WHITLEY COUNTY BOARD OF ZONING APPEALS STAFF REPORT

24-W-VAR-3 DEVELOPMENT STANDARDS VARIANCE

Brooks Langeloh 2740 W. 700 North FEBRUARY 27,2024
AGENDA ITEM: 3

WEST LOON (PRELIMINARY)

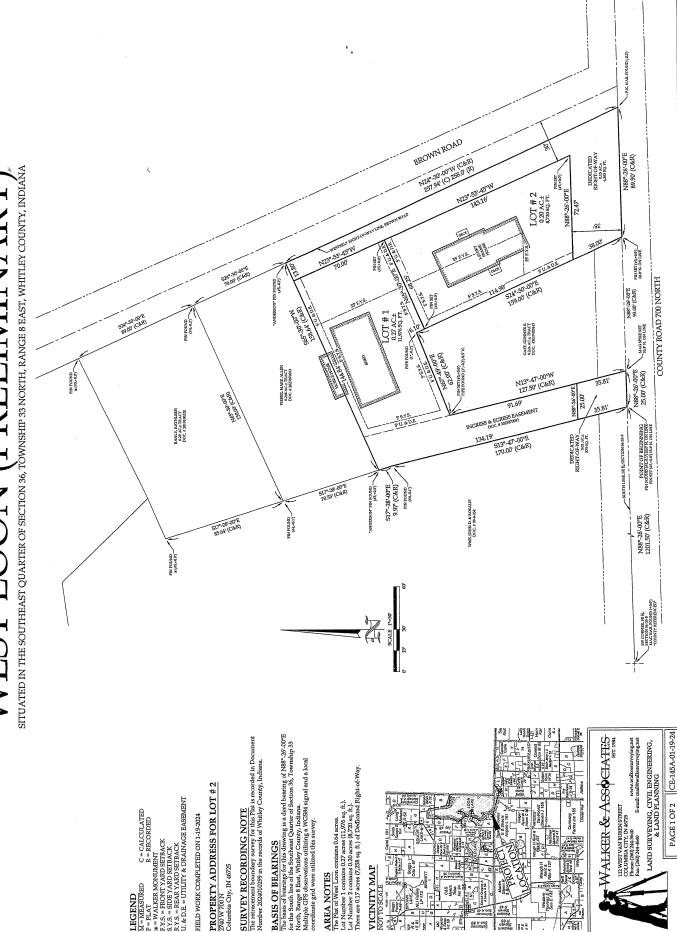
The proposed plat would break the existing U-shaped parcel into two more regular shaped lots. Lot 1 would contain the existing outbuilding, while Lot 2 would have the existing house.

Additionally, because the plat dedicates right-of-way for the adjacent public roads, and because there are existing improvements on each lot, setback encroachments are created. Because they are created by the nature of the plat requirements, these encroachments can be treated as legal nonconformances. However, the petitioner wishes to address the nonconformities now to reduce potential future difficulties in using the lots. This table shows the code and proposed setbacks and necessary variances (in bold) for the setback encroachments:

Front yard	Side yard	Rear yard
Code		35'	5' (current)	15' (primary)
			10' (as proposed)	5' (accessory)
Lot 1	existing	55'±	6'± (north)	NA
			26.5'± (south)	
	proposed	42'±	5'± (north)	
			5'± (south)	
Lot 2	existing	32'± (Brown Road)	27'± (north)	NA
		45'± (700 North)	14'± (west)	
	proposed	17'± (Brown Road)	5'± (north)	
		30'± (700 North)	5'± (west)

Note that the side yard standard is variable as the code requirement is 5' for existing lots created prior to the adoption of the code in 2006, while it is 10' for lots created after 2006. Since the proposed plat would create new lots, the 10' standard would apply. Also note that the existing parcel and proposed lots both are

The strict application of the Ordinance terms would result in practical difficulties for setbacks, as the required dedication of rights-of-way creates encroachments in front setbacks and would leave only a 23' buildable width for Lot 2. Additionally, the side setbacks differ because they are intended to apply to entirely new lots, whereas this site includes existing improvements. This is further reflected in the petitioner's request to maintain the existing 5' side setbacks, even where the existing improvements would be compliant with the 10' setback.

The lot variances also have practical difficulties. The area of Lot 2 could be made compliant by taking a strip from the western side of Lot 1 and the access easement, but such a strip would be useful only for code compliance. Practically, it would become a matter of contention between lot owners and a likely maintenance problem. Other solutions to the lot area would create further variances or encroachments. The lot width request originates, like the setback variances, from the dedication of right-of-way along Brown Road, which is an imposition of the subdivision code.

1. The plat be amended with the setback lines as approved and a notation of this variance approval.
